**PLANNING COMMISSION  
SITE PLAN WAIVER REQUEST REVIEW SHEET**

**CASE:** SP-2020-0202C

**PROJECT NAME:** 15th St Office Building

CITY OF AUSTIN – DEVELOPMENT SERVICES DEPARTMENT  
SITE PLAN APPLICATION – MASTER COMMENT REPORT

## W. 15th Street Facade

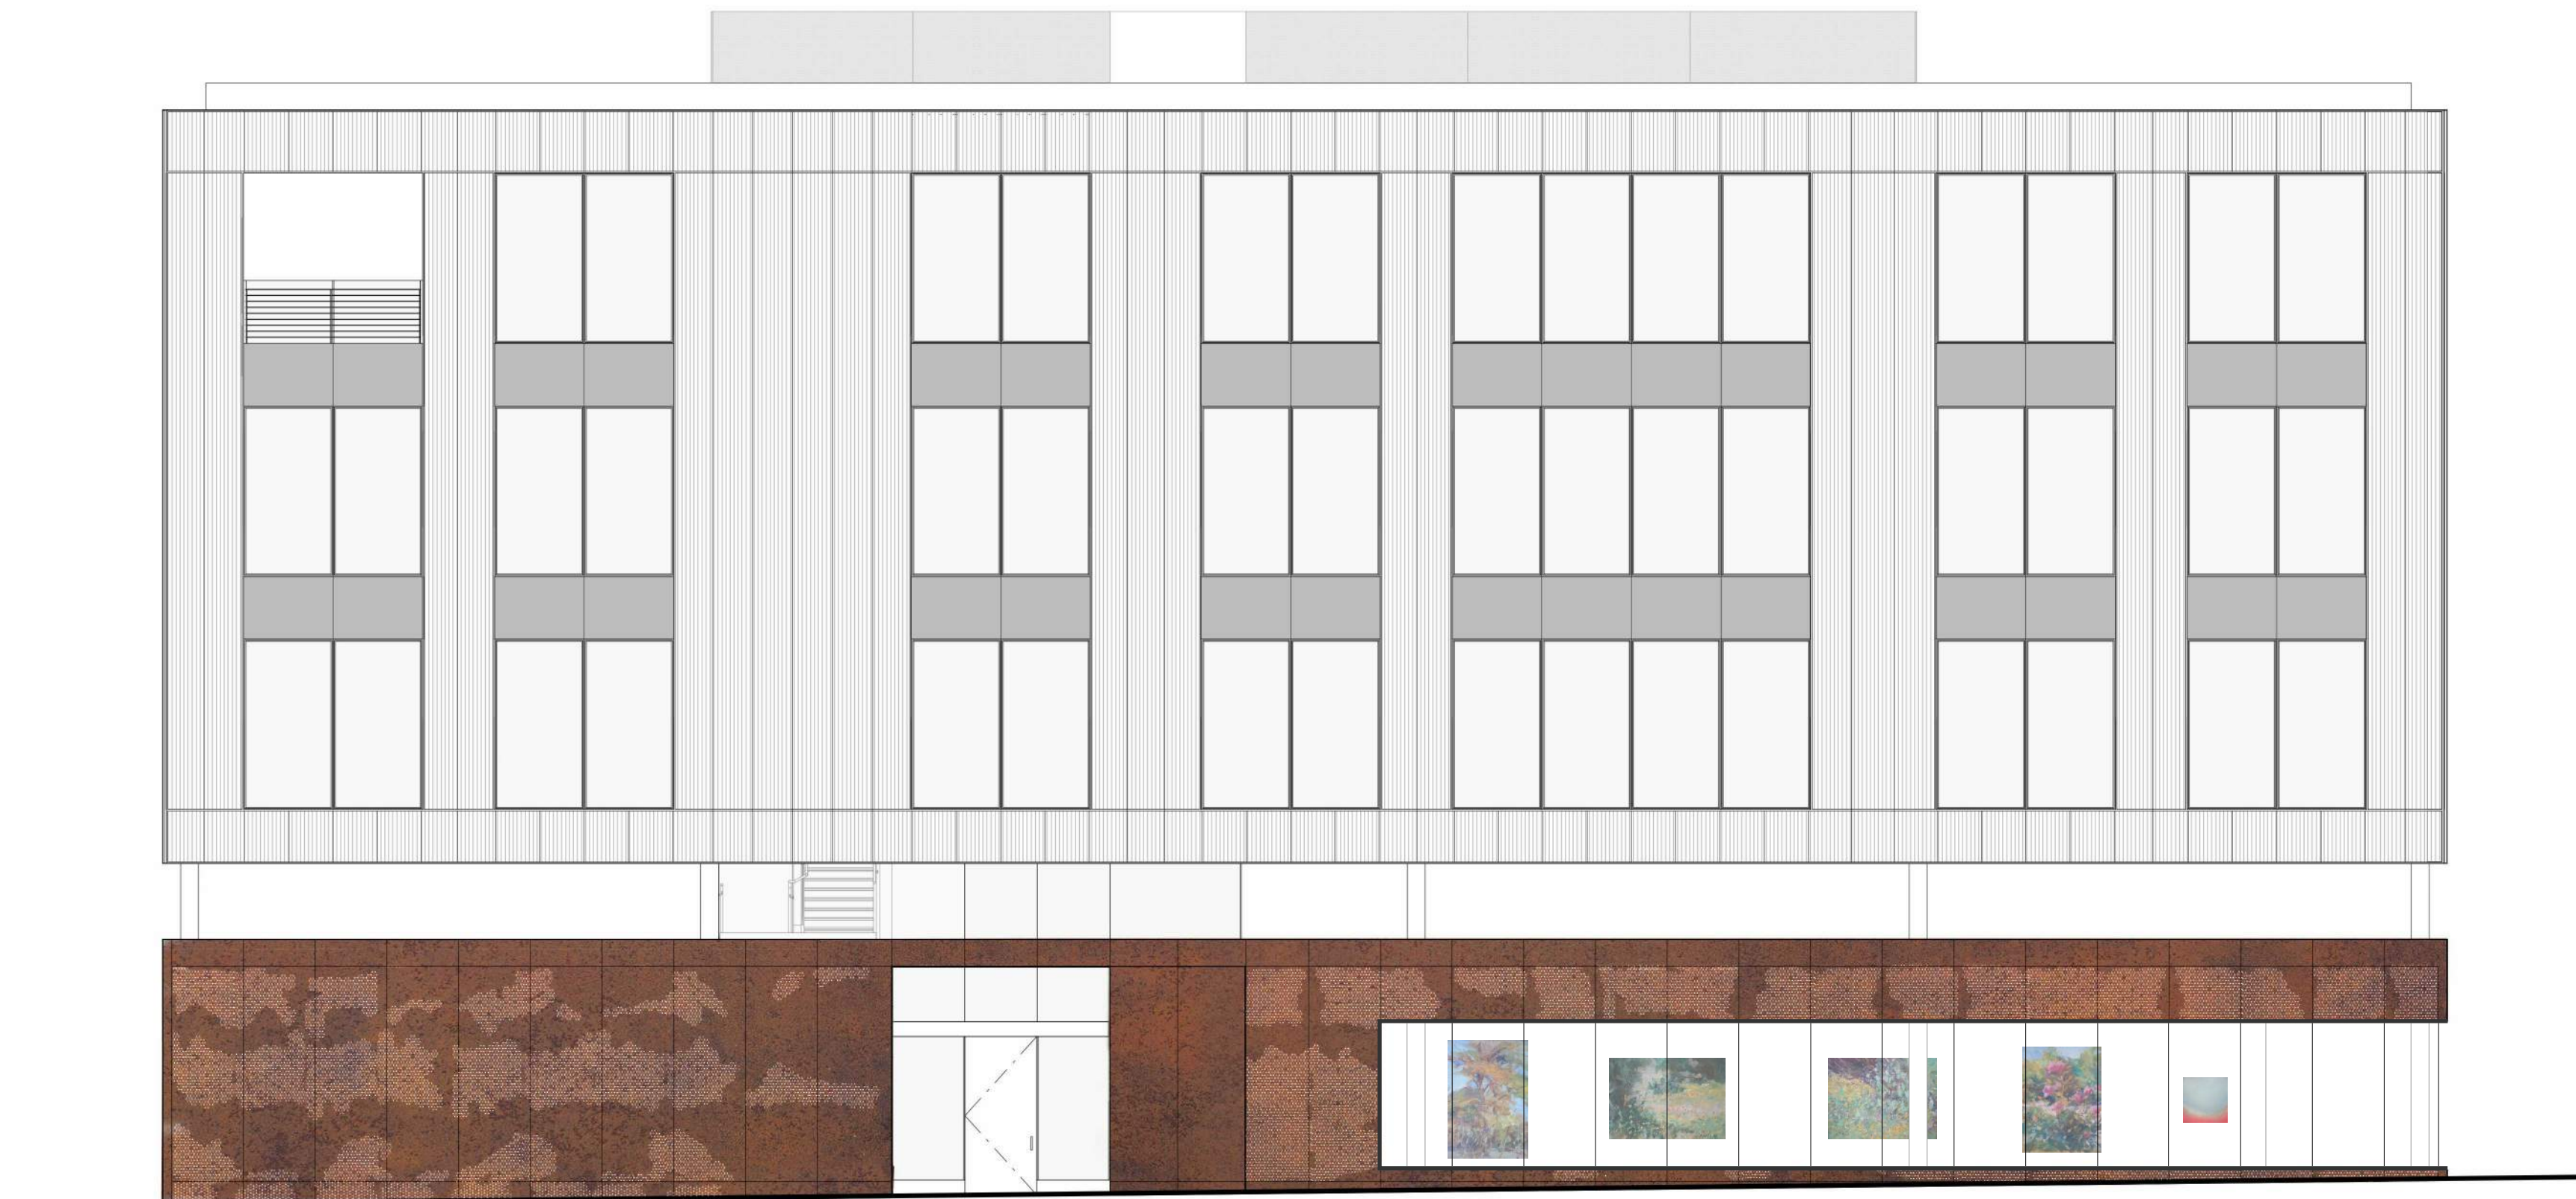
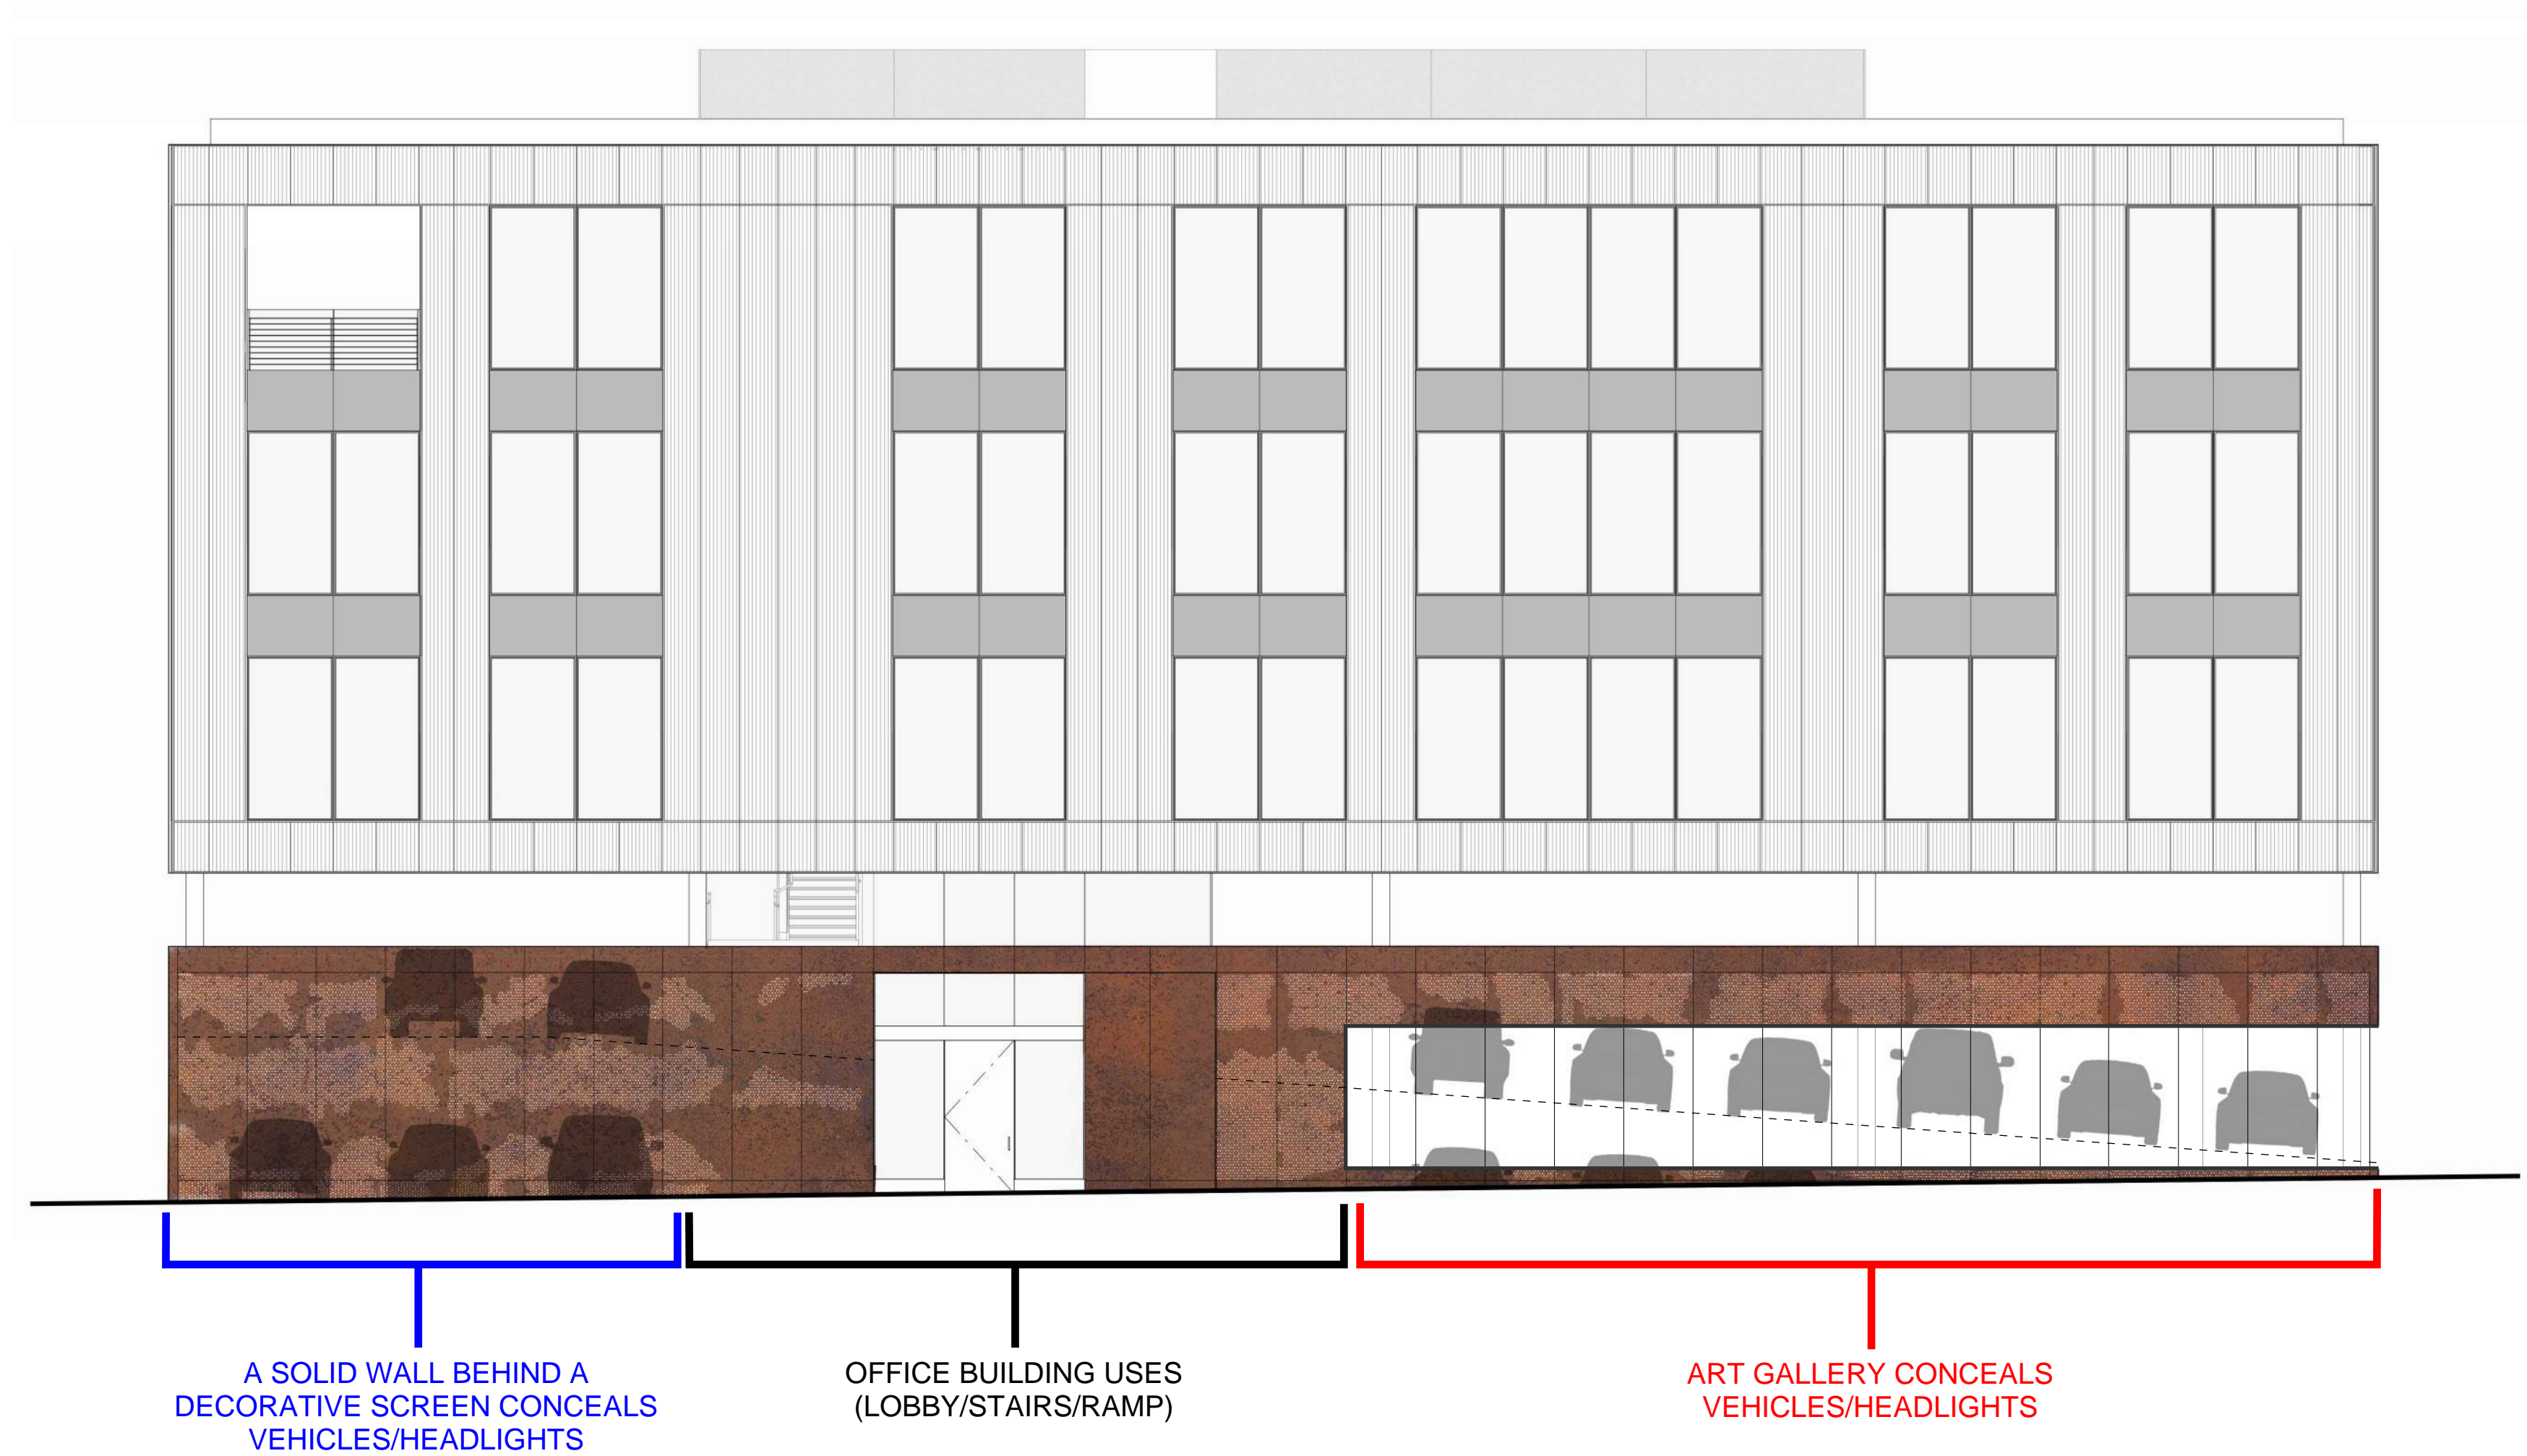
VEHICLES ARE COMPLETELY CONCEALED FROM VIEW  
WHEN WALKING ON THE SIDEWALK ALONG W 15TH STREET.
